# Sunrise Project

## Project Execution Plan Modification

Submissions Report

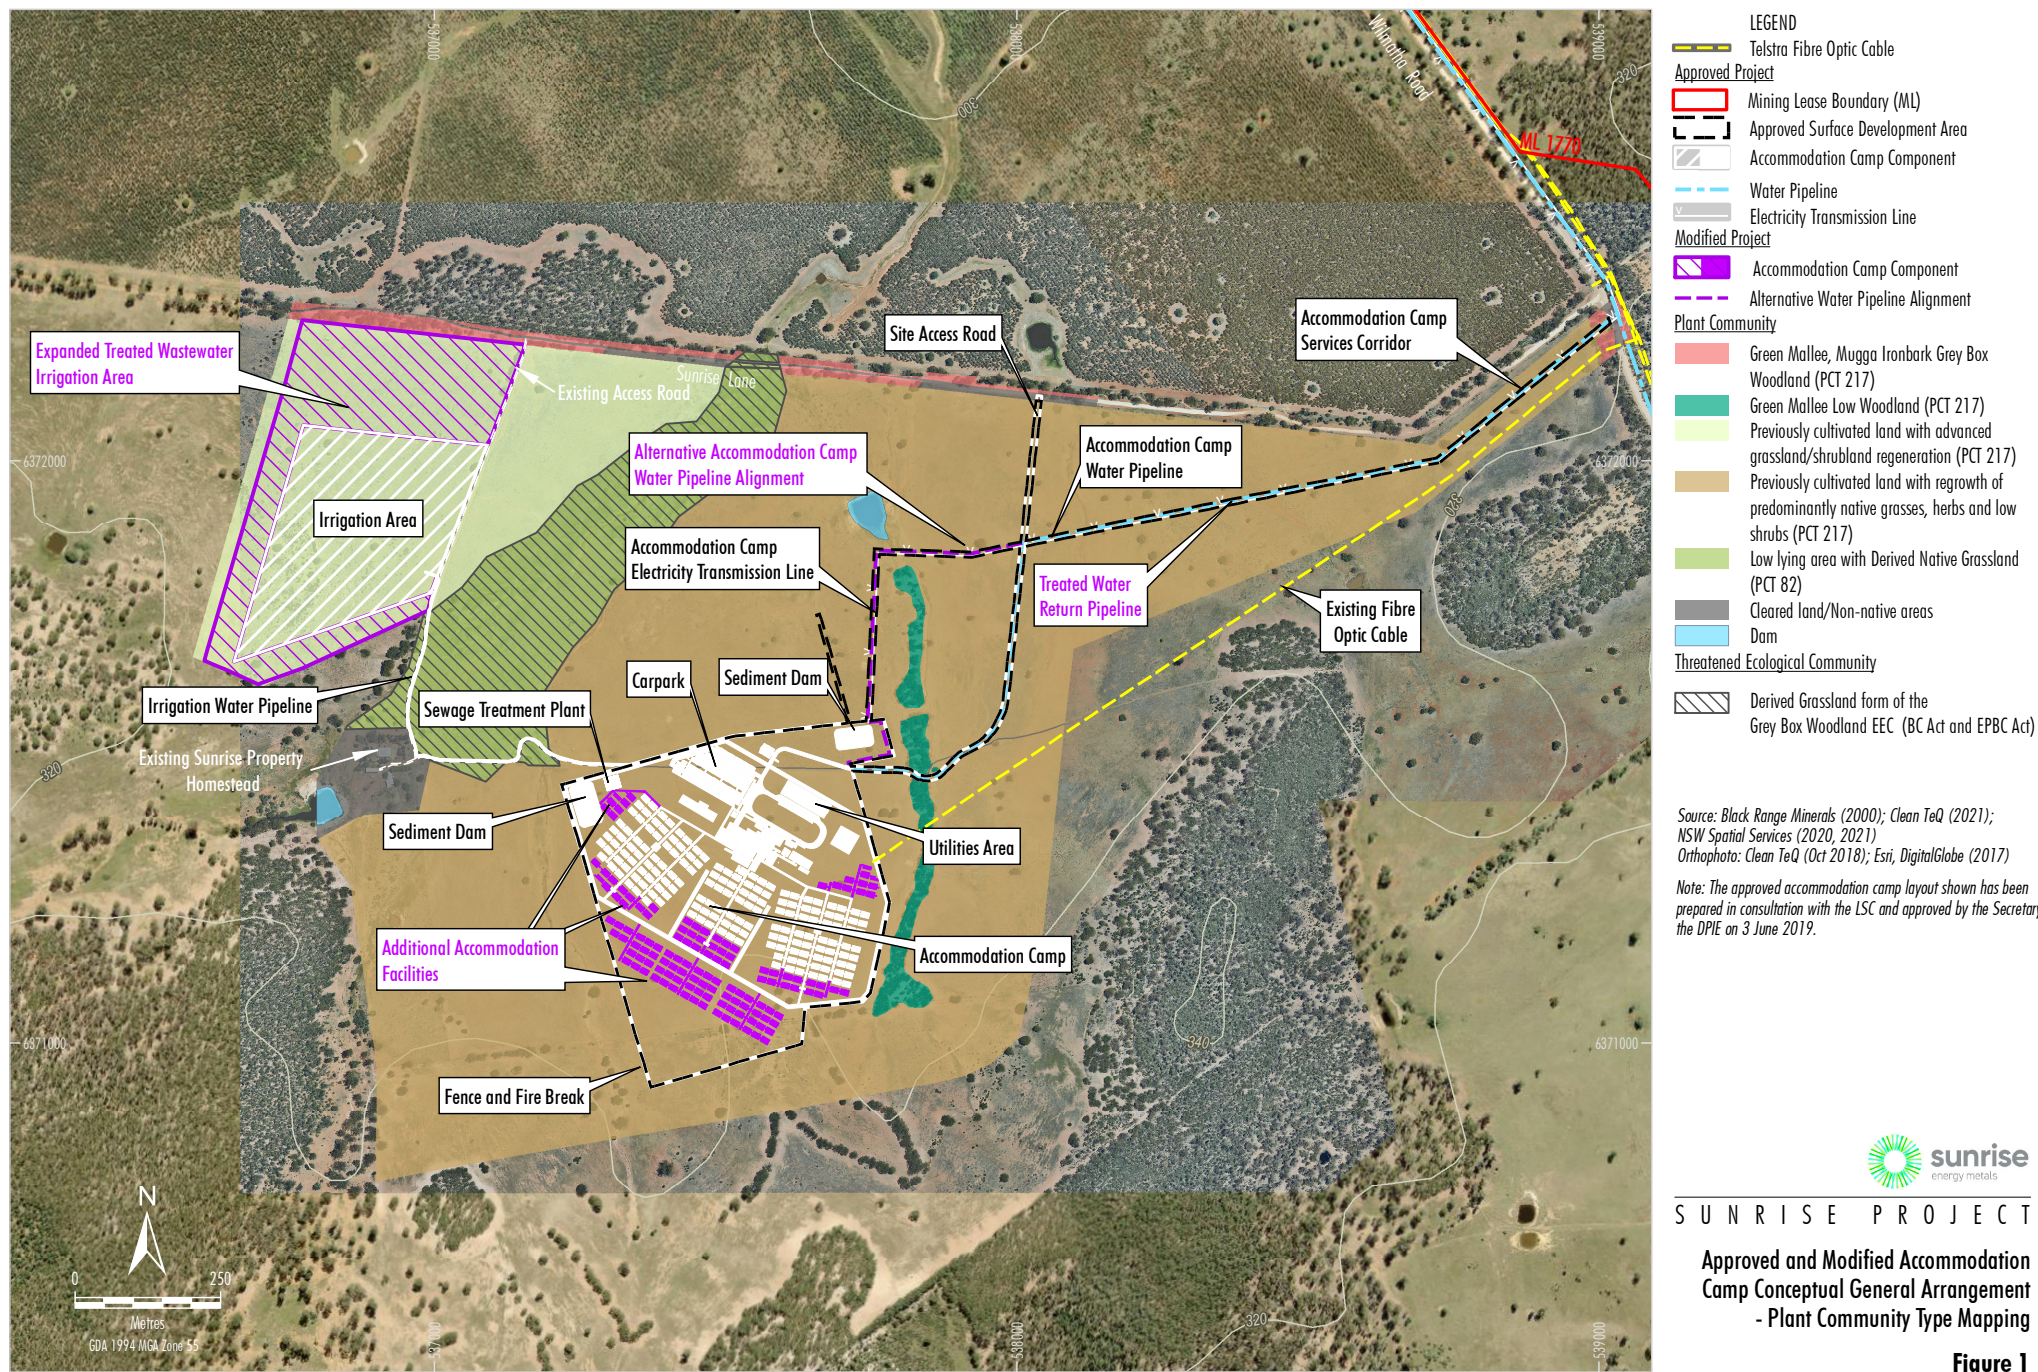
The Biodiversity, Conservation and Science Directorate (BCS) provided a submission on the Modification via letter on 10 August 2021 which requested additional information regarding the potential biodiversity impacts of the Modification. Specifically, the BCS requested additional information regarding the assessment of the potential impacts on biodiversity values associated with (Figure 1):

- the accommodation camp water pipeline alternative alignment; and
- the expanded treated wastewater irrigation area.

The Modification would include the option for an alternative alignment of the last section of the accommodation camp water pipeline along the accommodation camp services corridor, rather than along the access road corridor (Figure 1). As the alternative alignment of the accommodation camp water pipeline would be wholly located within the approved surface development area, no additional native vegetation clearance (i.e. no additional direct impacts) would be required.

The Modification would increase the size of the treated wastewater irrigation area from approximately 10.5 hectares (ha) to approximately 21 ha (i.e. an approximate 10.5 ha increase) (Figure 1).

Both the approved and expanded treated wastewater irrigation areas would be located over previously cultivated land with advanced grassland/shrubland regeneration (PCT 217) (Vegetation Community 1c)<sup>2</sup> (Figure 1). Consistent with the approved treated wastewater irrigation area, no native vegetation clearance (i.e. no direct impacts) would however be required for the expanded treated wastewater irrigation area. The BAM only requires the determination of the biodiversity credits for residual direct impacts.
